# Market Street Development an analysis

city & county of san francisco  
market street design task force

EVALUATION OF DESIGN PROPOSALS FOR MARKET STREET SUBWAY  
STATIONS AND DEVELOPMENT OF THE STREET SURFACE

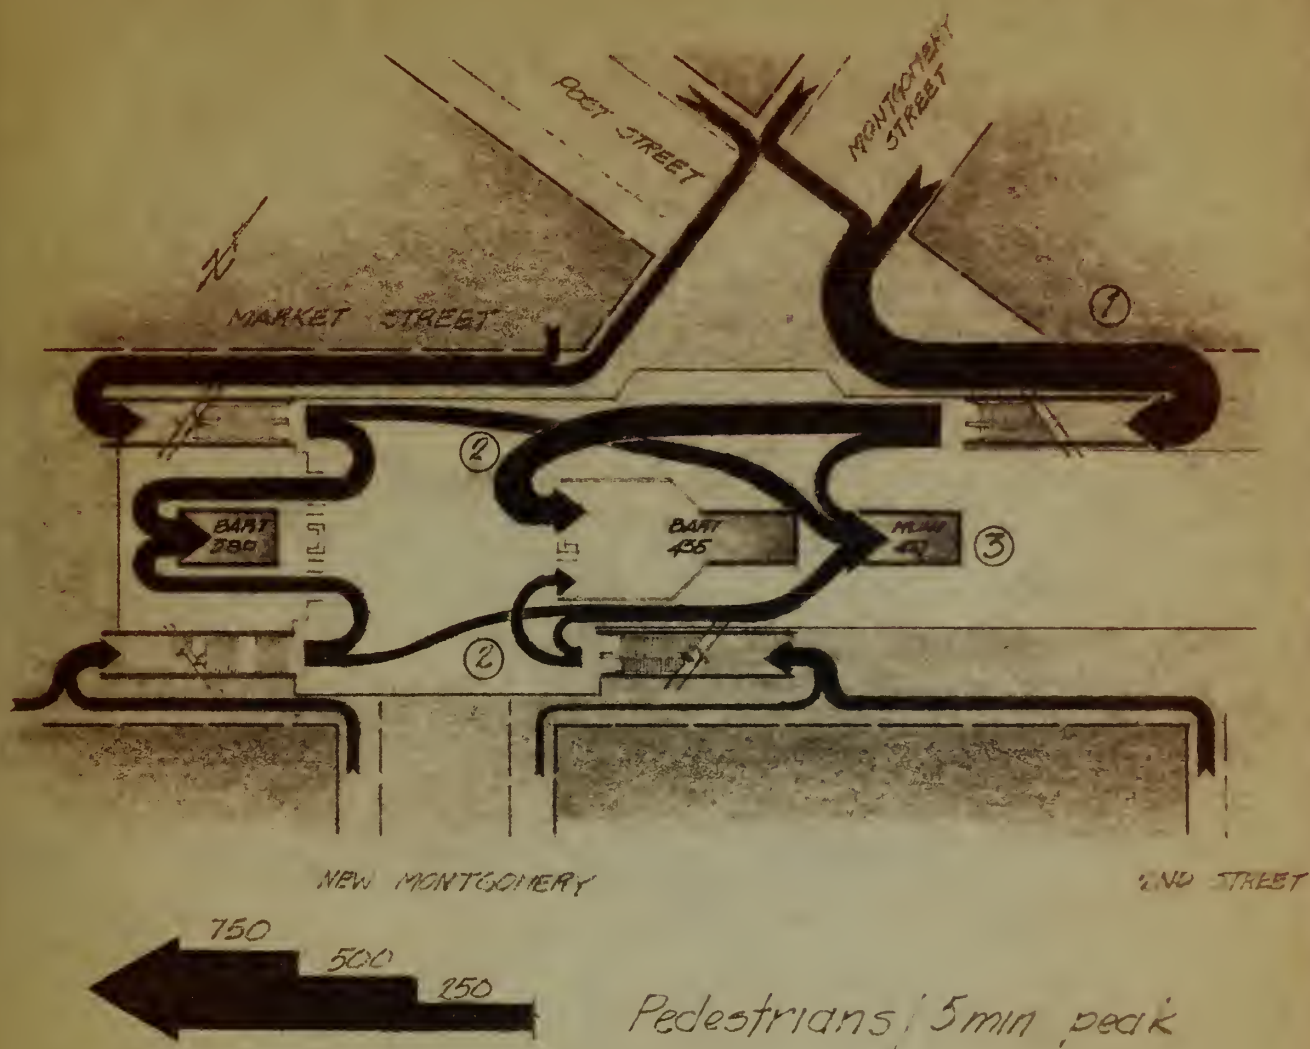
On the basis of technical data developed to date, as illustrated on the attached charts, it appears that the four traffic lanes shown on Scheme "B" would be inadequate to accommodate existing and projected flow of transit vehicles, trucks, taxis and private automobiles. Scheme "B" provides for 35' sidewalks on each side of Market Street. More than four traffic lanes would result in sidewalk widths of less than 35'. Along the length of Market Street, changing pedestrian and vehicular volumes may require variations in the widths of sidewalks.

Although 35' sidewalks would provide generous space for pedestrians and amenities, the width of sidewalks cannot be finally determined until the question of vehicular use of the street has been resolved. Major traffic and transit studies now in progress will have an important bearing on the resolution of this question.

West end - Montgomery Street Station

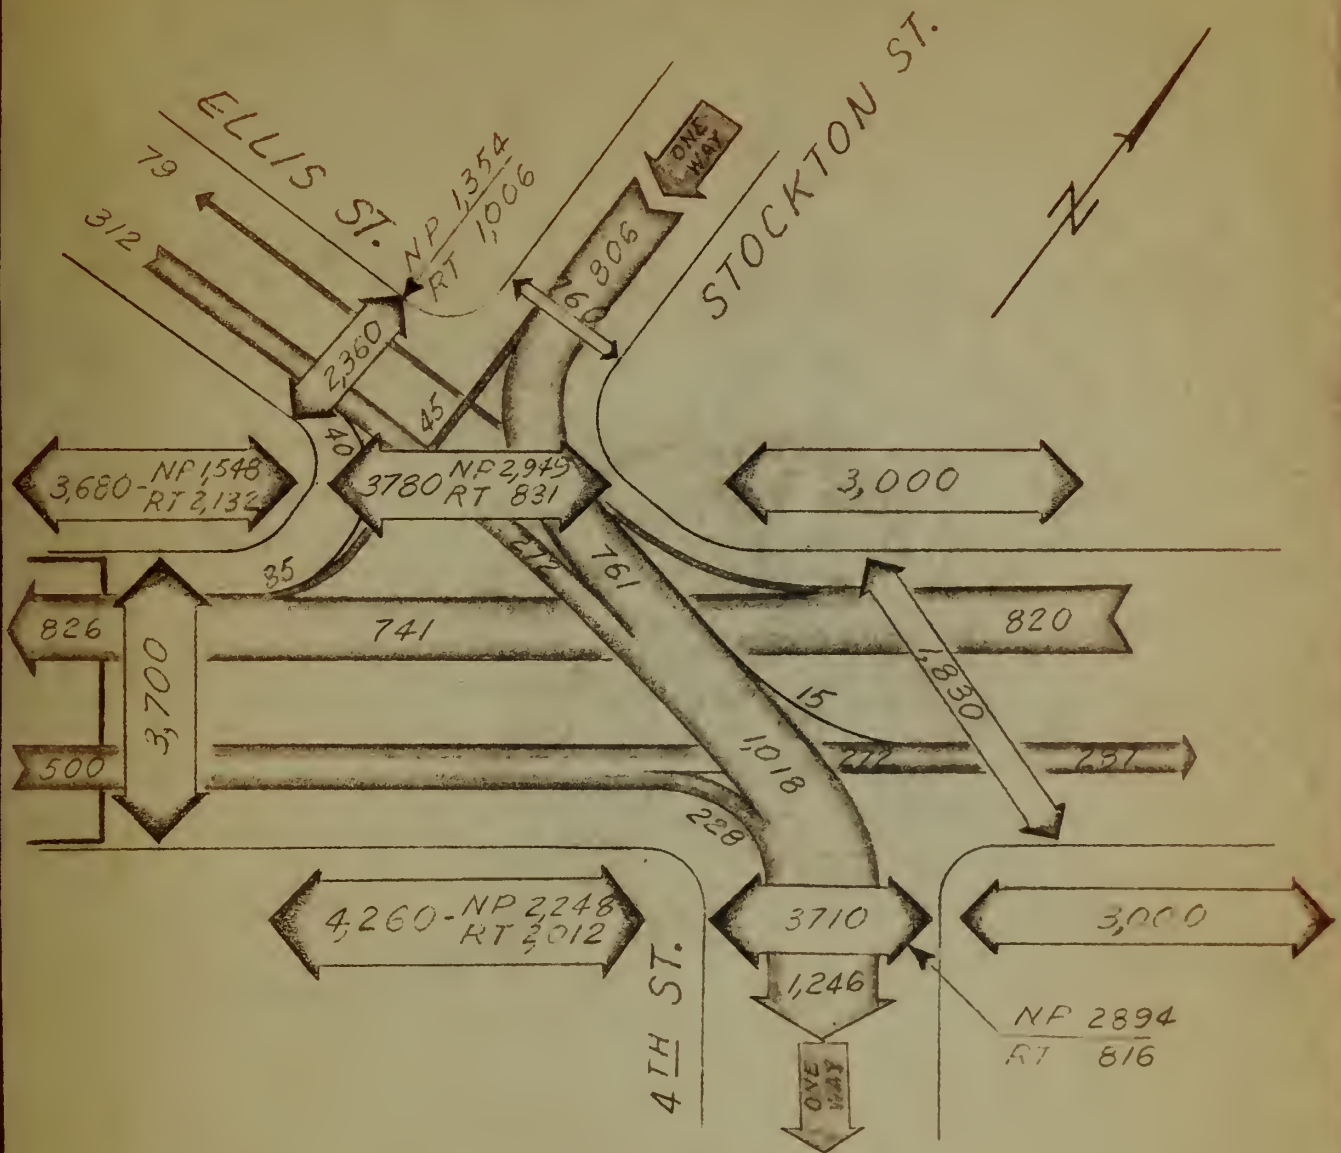
1. Pedestrians forced through narrowed walks
2. Conflicting patronage movements
3. Location of Municipal Railway access
